Re: Support Draft Bay Delta Conservation Plan (BDCP) and Associated  
Draft Environmental Impact Report/Environmental Impact Statement  
(EIR/EIS) Alternative #4

RE: City of Brentwood Comments to the Bay Delta Conservation Plan Draft  
EIR/EIS

**Re: Bay Delta Conservation Plan Draft EIR/EIS**

Re: Comments on Bay Delta Conservation Plan and Draft EIR/EIS

Figure 7. NAA-LLT and Alt 4-LLT Simulated Nimbus Release

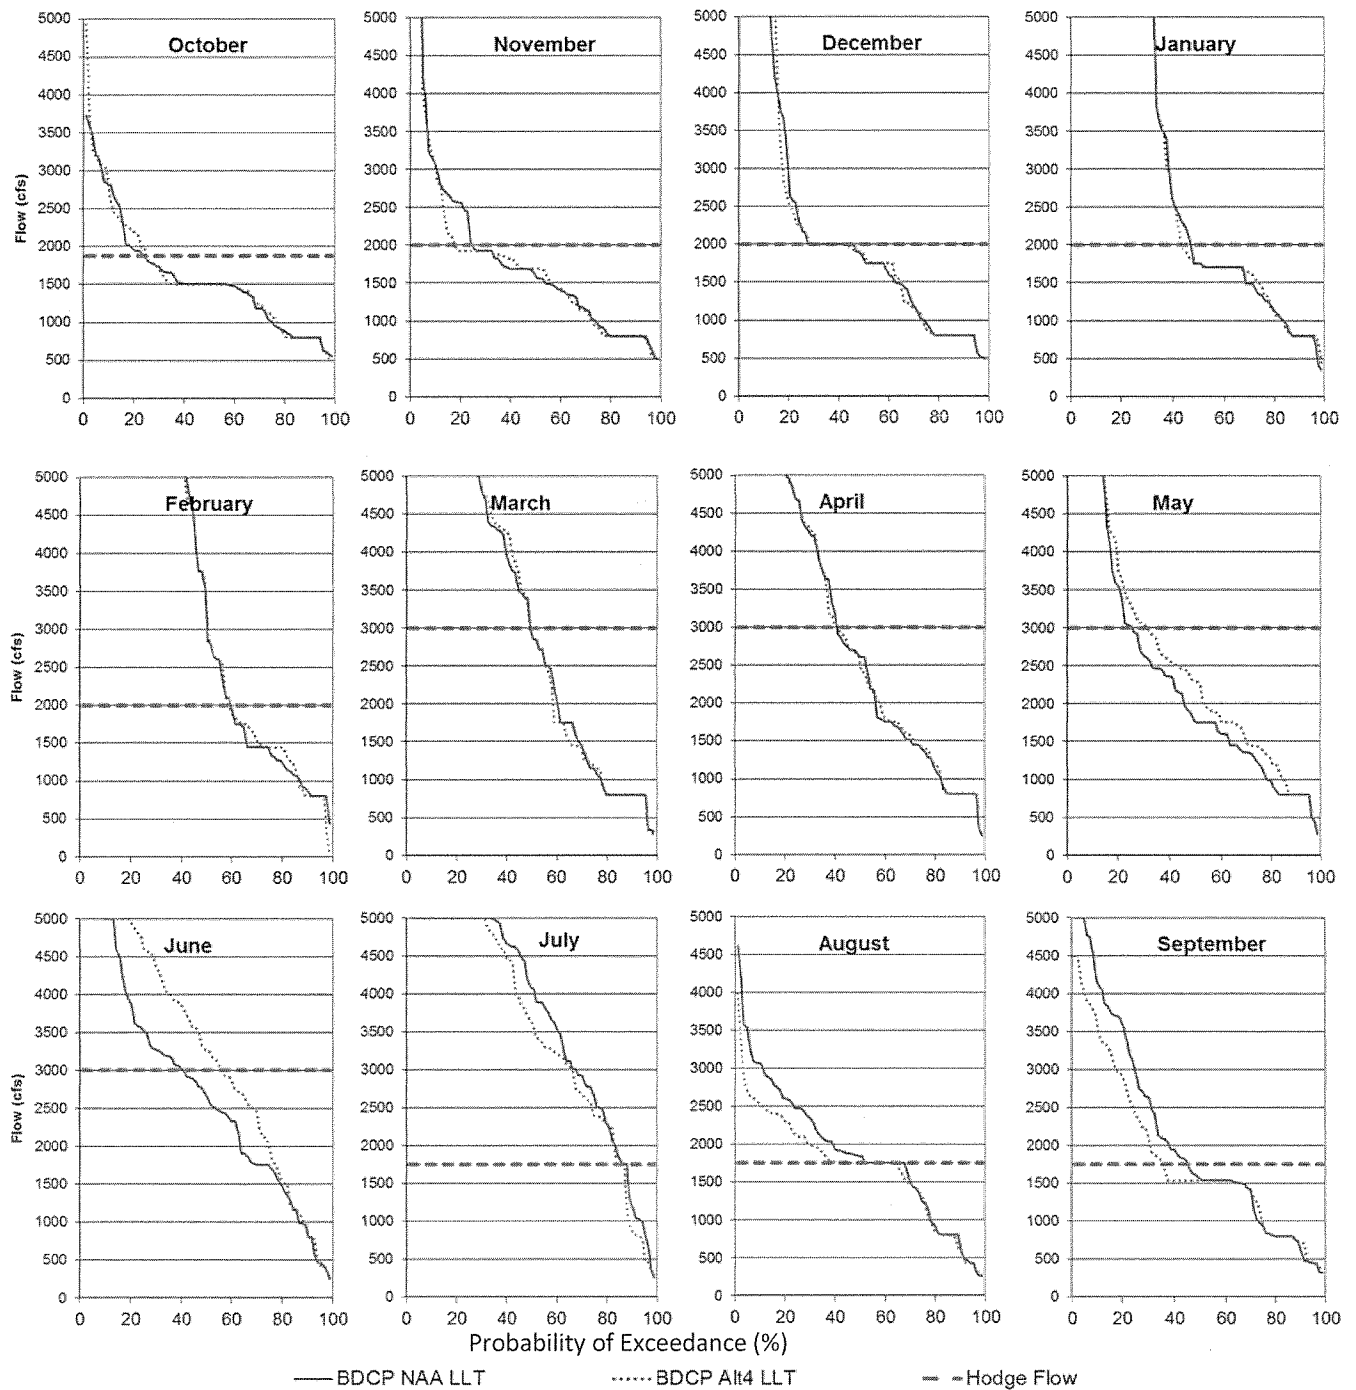
Figure 7 and Figure 8 contain comparisons of simulated monthly flow at Nimbus and H Street for the NAA-LLT and Alt4-LLT scenarios. Results show that under the Alt4-LLT American River flow is higher in the months of May and June, and lower in July, August, and September. Higher releases in May and June drive changes in Folsom storage and water surface elevation seen in previous figures. Likewise, lower releases from July through September bring simulated end-of-September storage between the baseline and with-Project scenarios closer. BDCP modeling shows a higher probability of Lower American River flows being above Hodge Flows in May and June and a higher probability of flows being below Hodge Flows in July, August, and September. When Nimbus releases are below Hodge Flows, diversion limitations under the City of Sacramento's American River water right permits for the Fairbairn Water Treatment Plant on the American River constrain the amount of water available to divert. The changes in American River flows will affect the location of the City of Sacramento's diversion, but this is not reflected in the BDCP modeling. There are also limitations on the City's Sacramento River diversion capability, which could interfere with any such shift in the location of diversions, and hence reduce the supply available to the City. This is not reflected in the BDCP modeling. In the Alt 4-LLT the City of Sacramento will be able to divert more water from the American River at Fairbairn during May and June and less during August and September.

Figure 8. NAA-LLT and Alt 4-LLT Simulated H Street Flow

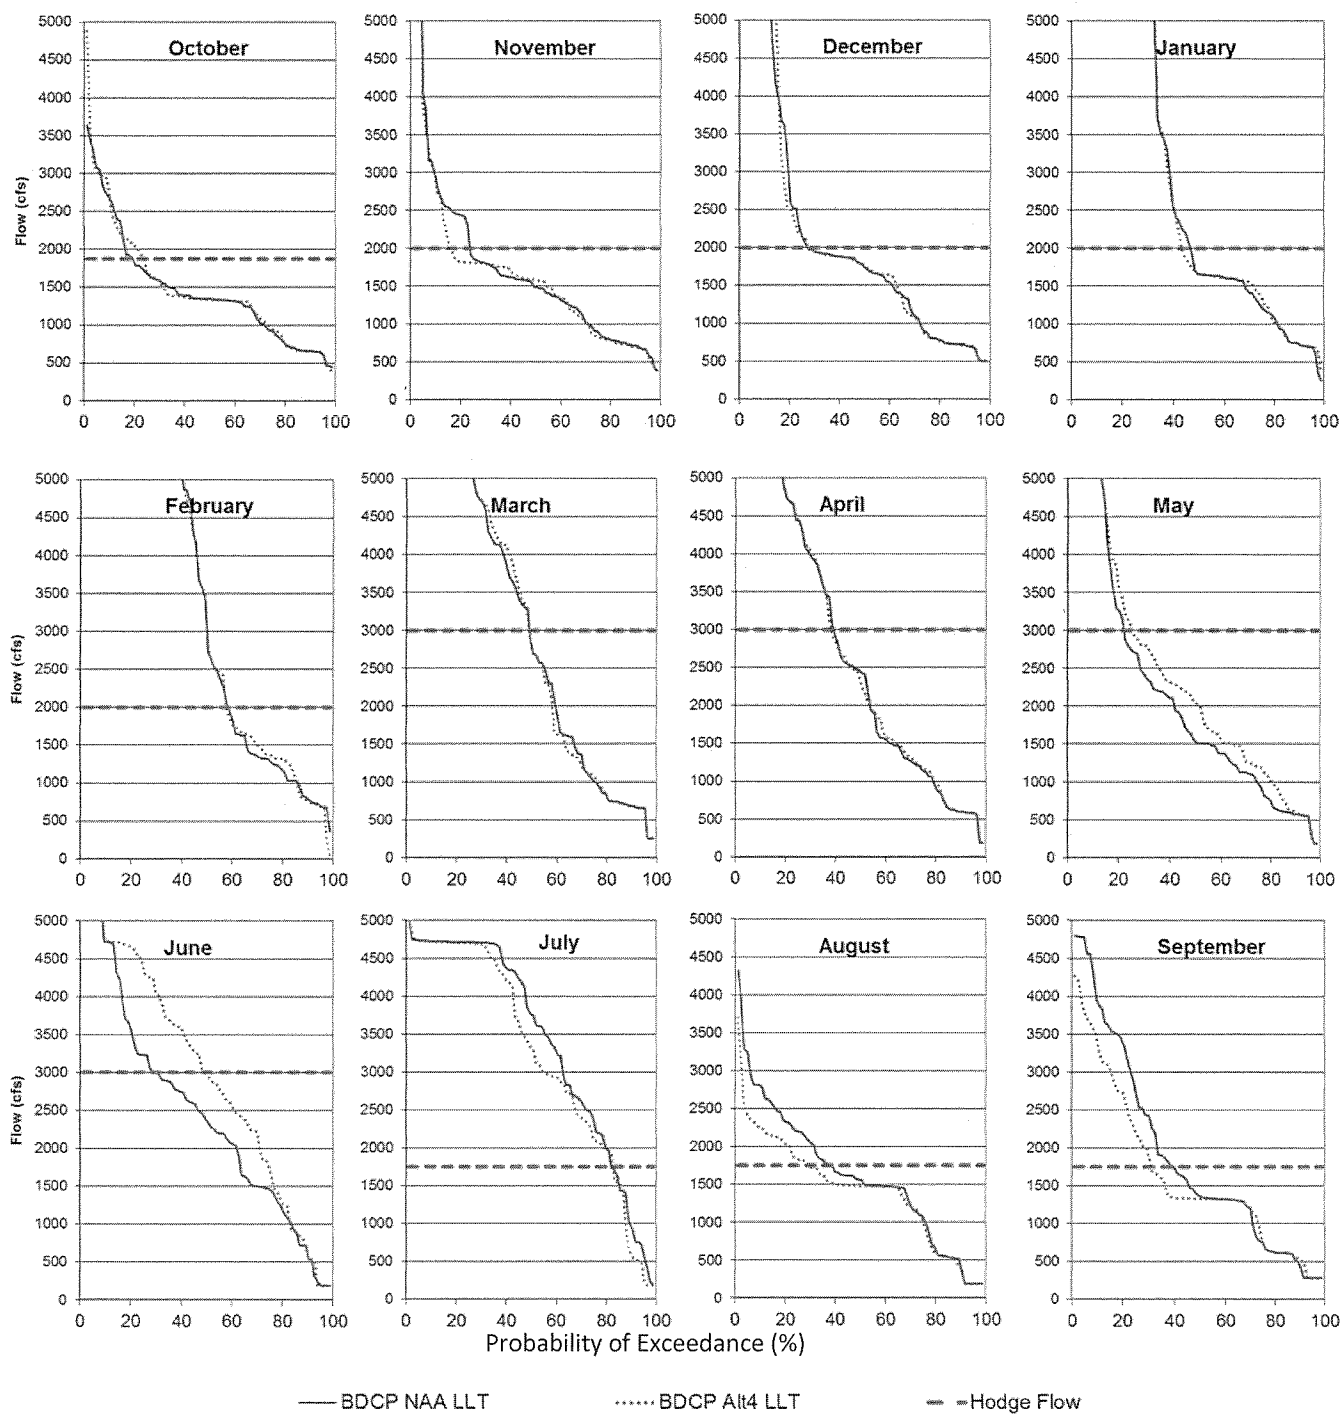
Flow in the lower American River at H Street drops below 500 cfs in both the NAA-LLT and Alt4-LLT. This is critical for the City of Sacramento because their ability to divert water from the American River is affected when flow at H Street falls below 500 cfs due to the potential for pump cavitation. There are times when American River at H Street falls below 500 cfs more often in Alt 4-LLT than in the NAA-LLT. Water availability to the City of Sacramento, including under its settlement contract with Reclamation<sup>14</sup>, would be curtailed or eliminated on the American River when water levels in Folsom Reservoir drop below to dead pool level of 90,000 AF.

**Figure 9. NAA-LLT and Alt 4-LLT Simulated Sacramento River Flow at the American River**

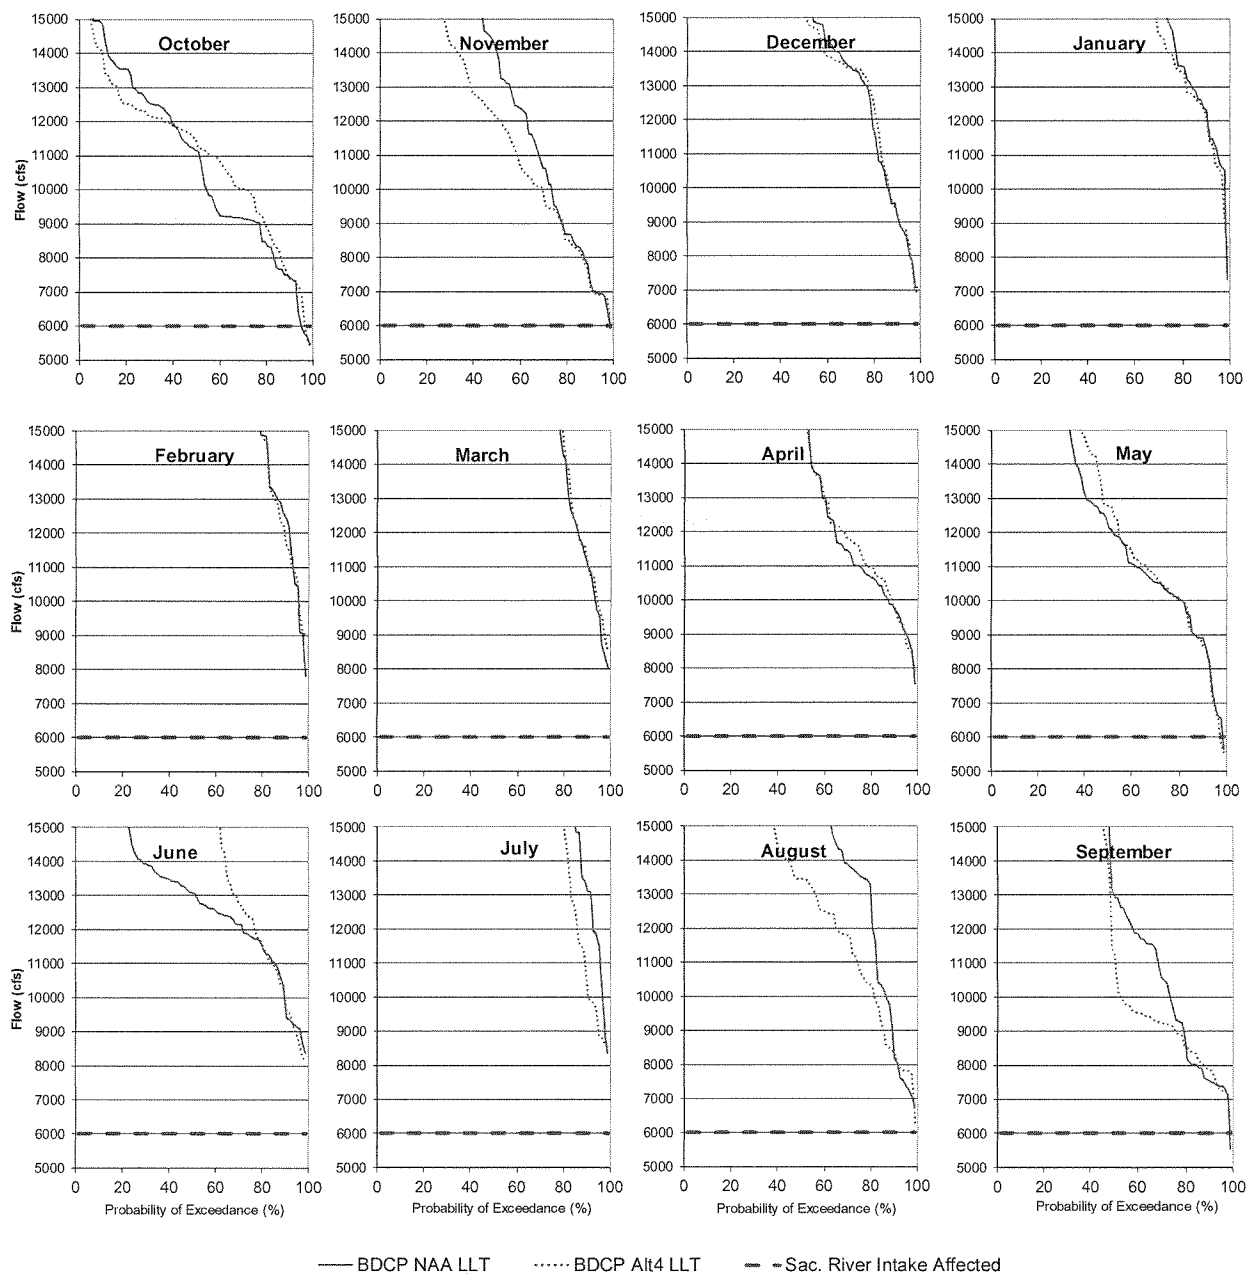
Figure 9 contains comparisons of simulated monthly flow in the Sacramento River at the confluence of the American River for the NAA-LLT and Alt4-LLT scenarios. When Sacramento River elevation falls below two feet above sea level (NGVD 1929) the City of Sacramento's intake structure capacity is reduced. Elevation 2.0 occurs when the flow rate is between approximately 5,000 cfs and 9,000 cfs and depends on tidal variation. Moreover, flow rates below 5,000 cfs may result in cavitation or vortexing, causing significant pump damage. Based on CalSim II modeling results, the frequency of the Sacramento River falling below 6,000 cfs is similar in the NAA-LLT and Alt4-LLT.

**Figure 10. CVP North of Delta M&I Water Service Contract Allocation**

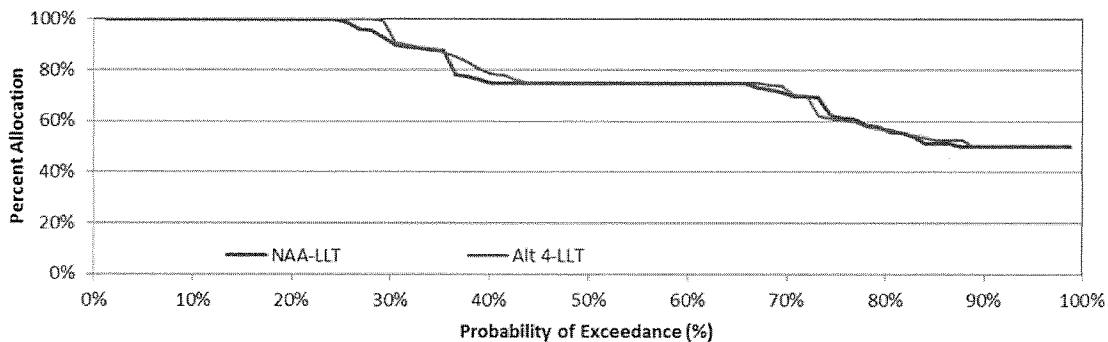
Figure 10 is an exceedance probability plot of CVP North of Delta M&I Water Service Contract Allocation for the NAA-LLT and Alt4-LLT. Changes in these allocations would affect the numerous CVP water-service contractors in the American River Basin, including the cities of Folsom and Roseville, Placer County Water Agency, SMUD and Sacramento County Water Agency. Average annual allocation to CVP M&I water service contractors is about 78% and increases by about one half of one percent in Alt 4-LLT compared to NAA-LLT. Although allocation never falls below 50%, deliveries are not always met due to low reservoir and river flows

**Figure 5a. Summer (July - October) Monthly Mean End-of-Month of Storage Folsom Reservoir Storage (TAF) under the Existing Condition, No Action Alternative, and Preferred Alternative (Alternative 4).**

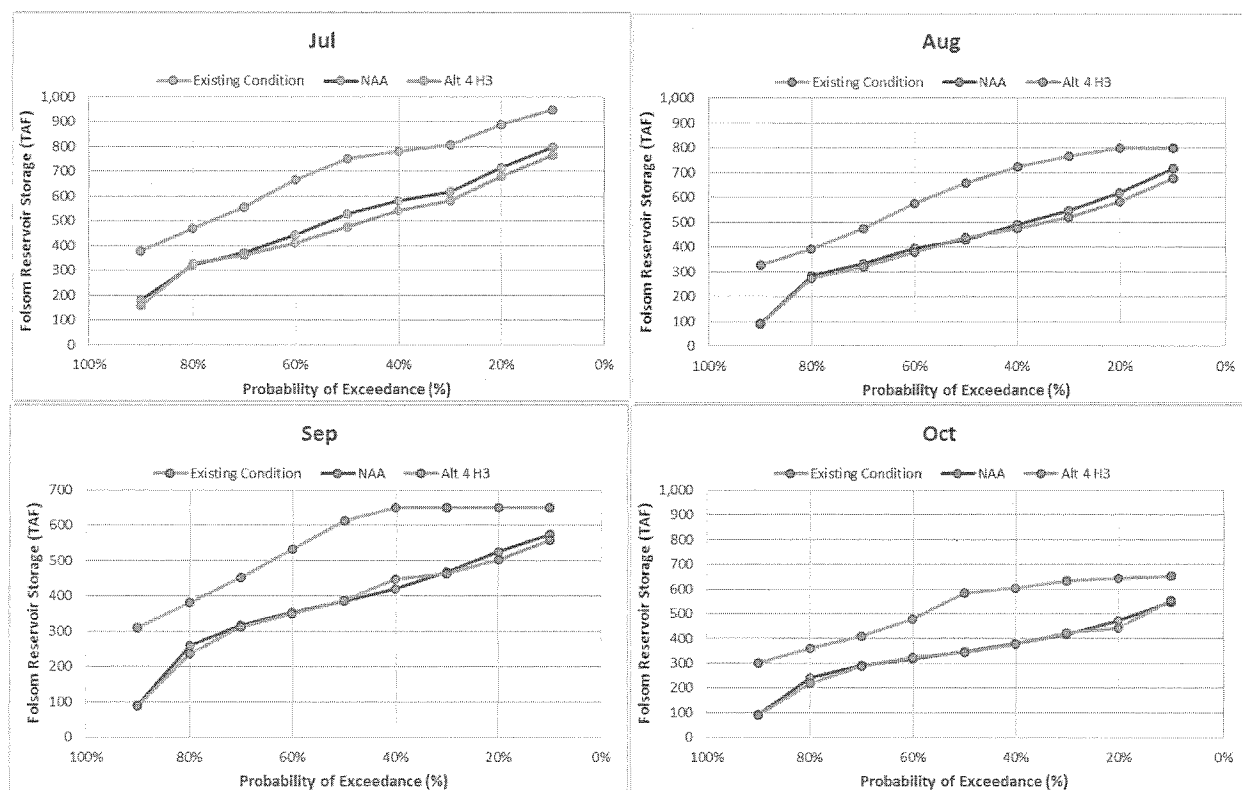
The operation of the CVP/SWP as modeled in the NAA with the sea level rise, climate change, and future demand assumptions results in much lower Folsom Reservoir storage elevations compared to existing conditions (Figures 5a and b) and greatly increased LAR water temperature. The frequency of Folsom Reservoir being at low storage levels (e.g., <350 thousand acre-feet [TAF]) would increase substantially in July and August under the NAA compared to existing conditions (increases from about 10% of the time under existing conditions to about 30% of the time under the NAA) (Figure 5a). In critical years, mean monthly

**Figure 6. Folsom Reservoir Storage (TAF) in Relation to ATSP Temperature Schedule<sup>1</sup>. Higher ATSP Schedules Correspond to Warmer Summer Temperatures. All Schedules Larger than 55 Exceed Summer Temperatures of 70°F.**

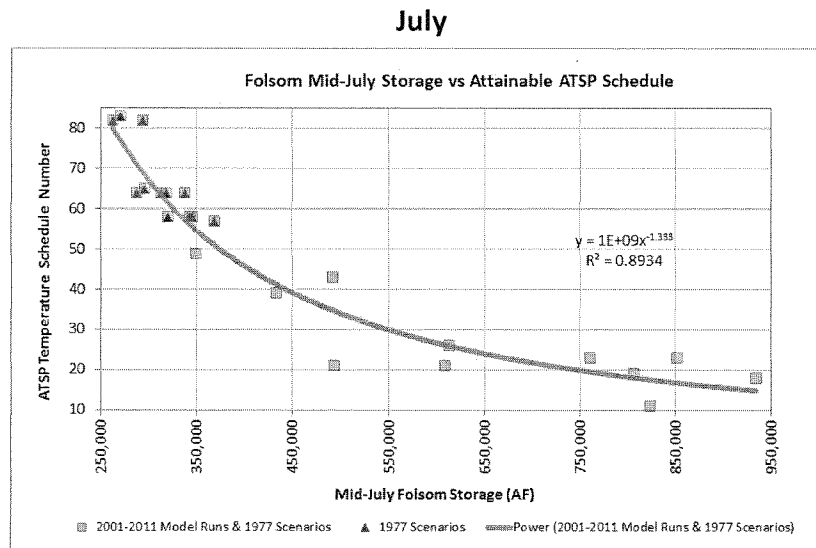
Higher American River summer temperature schedules occur when Folsom Reservoir storage drops, particularly as storage falls below 350 TAF in July. Figure 6 shows a relationship between the Folsom Reservoir storage in July and LAR water temperature schedules<sup>2</sup>. Figure 7 shows relatively large increases in fall water temperature below Nimbus Dam at low Folsom Reservoir water levels as reported in the BDCP EIR/EIS (and the associated Folsom Reservoir storage) under the NAA operations. These changes are most pronounced in drier years.
